UNITED STATES
DEPARTMENT OF THE INTERIOR
BUREAU OF LAND MANAGEMENT

FORM APPROVED
OMB NO. 1004-0137
Expires: January 31, 2018SUNDRY NOTICES AND REPORTS ON WELLS
Do not use this form for proposals to drill or to re-enter an
abandoned well. Use form 3160-3 (APD) for such proposals.

5. Lease Serial No.
NMNM92180
6. If Indian, Allottee or Tribe Name
7. If Unit or CA/Agreement, Name and/or No.
8. Well Name and No.
GOLD RUSH 31 FED 4
9. API Well No.
30-015-32768-00-S1
10. Field and Pool or Exploratory Area
NASH DRAW-BRUSHY CANYON
11. County or Parish, State
EDDY COUNTY, NM

PROPOSED PLUG & ABANDONMENT

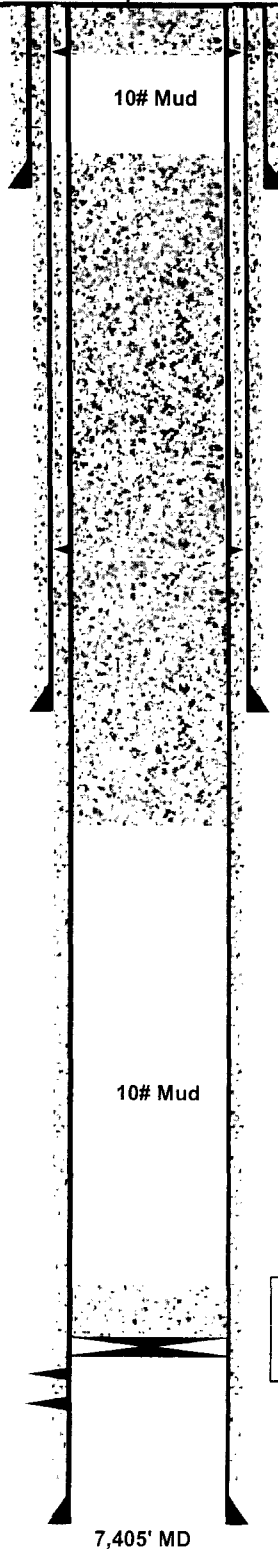
"Secretary's Aotash"
NOT R-111-A

3820-3129 (min)

720-575 (min)

** BLM REVISED ** BLM REVISED ** BLM REVISED ** BLM REVISED ** BLM REVISED **
